Harrisville City Planning Commission Harrisville City Offices Wednesday, May 10, 2023

Final Site Plan Approval
Harrisville Public Works Facility
May 2, 2023

RE: **HARRISVILLE CITY PUBLIC WORKS BUILDING**
Final Site Plan Review

Our office has completed a review of the final plat and improvement plans for the Ben Lomond Phase 2-D Subdivision located in the golf course mixed use zone. This phase includes the construction of the northeast section of the overall development and has 122 residential units including single family and multi-family units. Phase 2-A of the overall site will need to be constructed prior to construction of this phase as several of the street accesses and the utility connections will be built in Phase 2-A. There are still several outstanding items that need to be addressed for Phase 2-D:

2000 NORTH LIP PLAN & PROFILE STA. 18+00 - 24+00

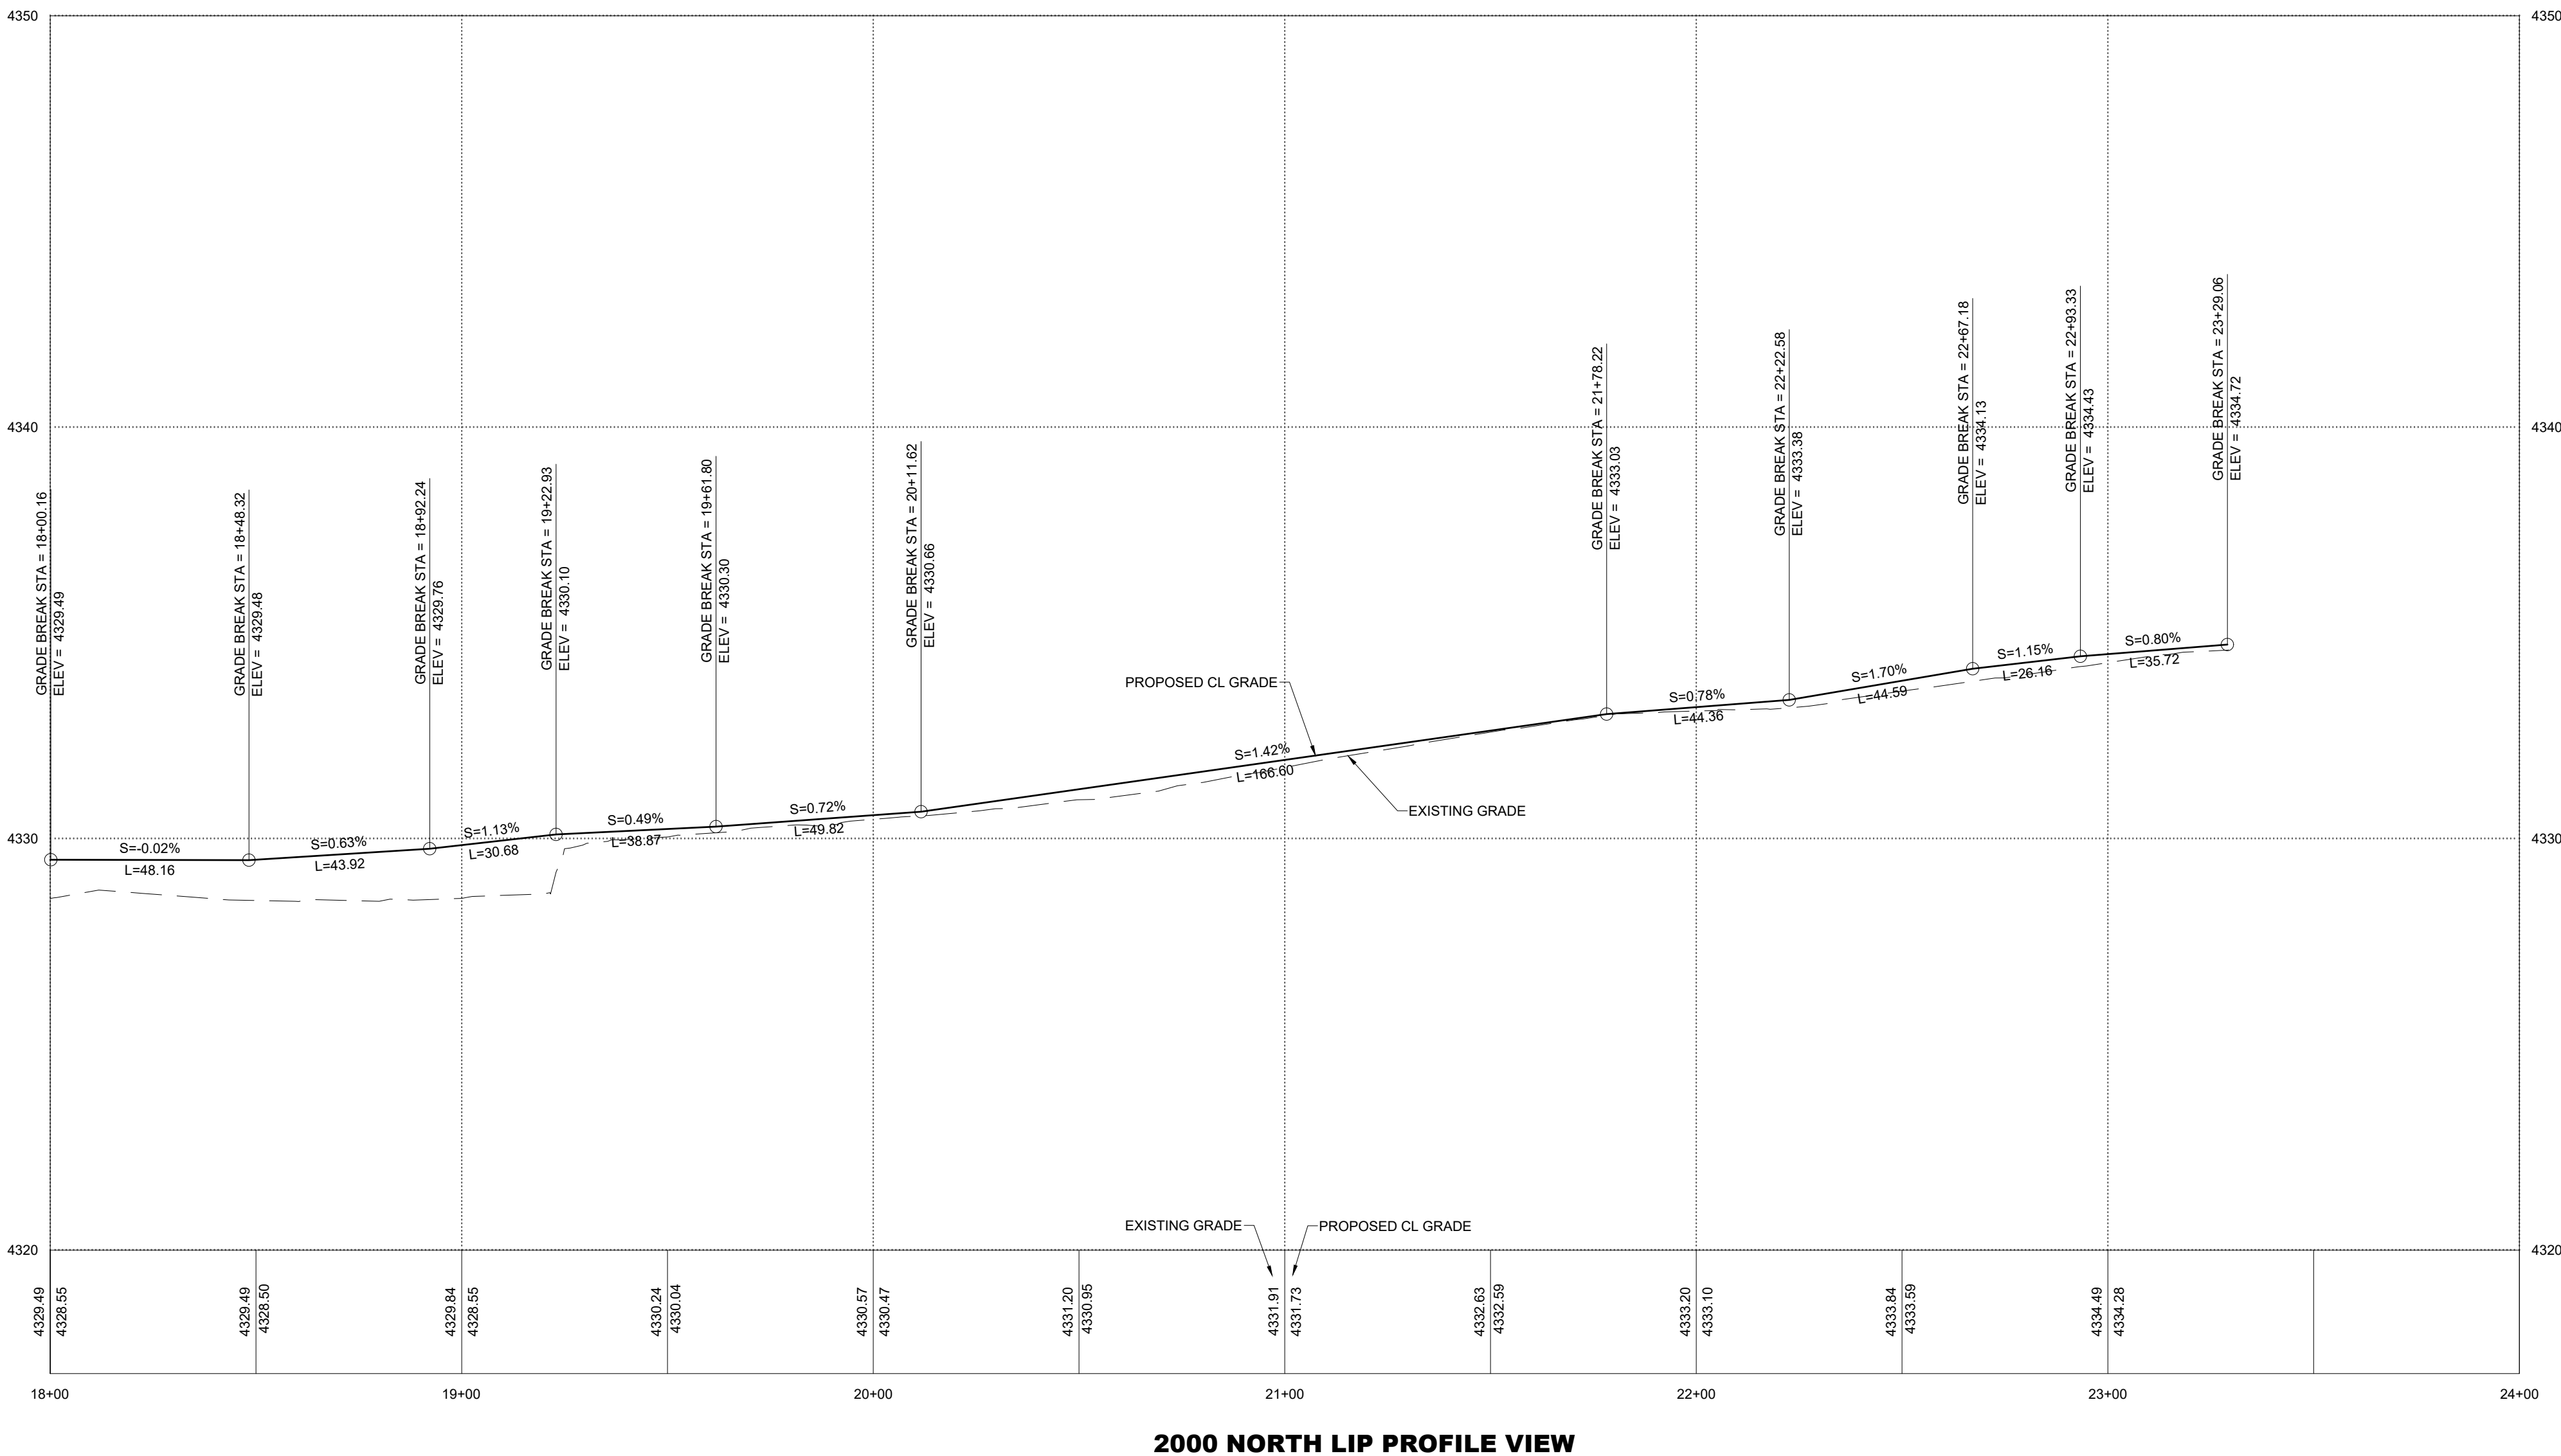
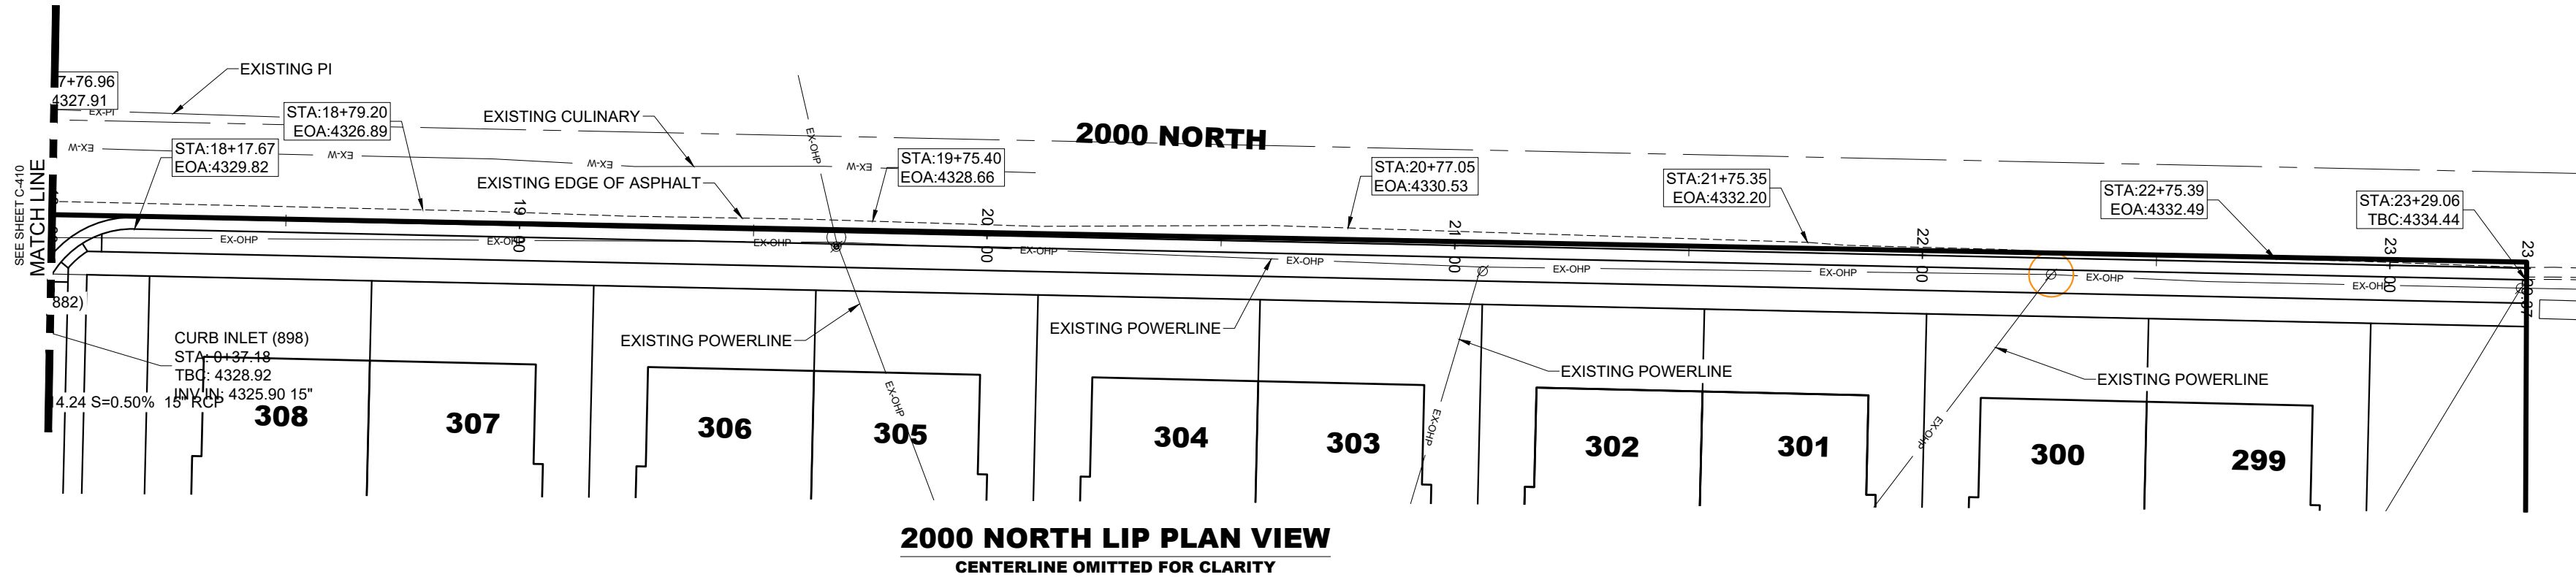
1. The asphalt tie-in and new curb and gutter elevations on 2000 North need to be portrayed in more detail on the plans. Additional asphalt and grading work may be required on the existing 2000 North roadway to ensure that it drains properly and matches the proposed curb and gutter.
2. The pavement section for the new roadways should match the City Standard (which is also what was approved in Phase 2-A).
3. Provide a "Will Serve" letter from Bona Vista Water for the culinary water improvements.
4. Provide a final approval letter from North View Fire District.
5. Provide improvement plans for the parks and open space included in this phase. Also, provide details or a plan for the required landscaping for this phase including street trees.
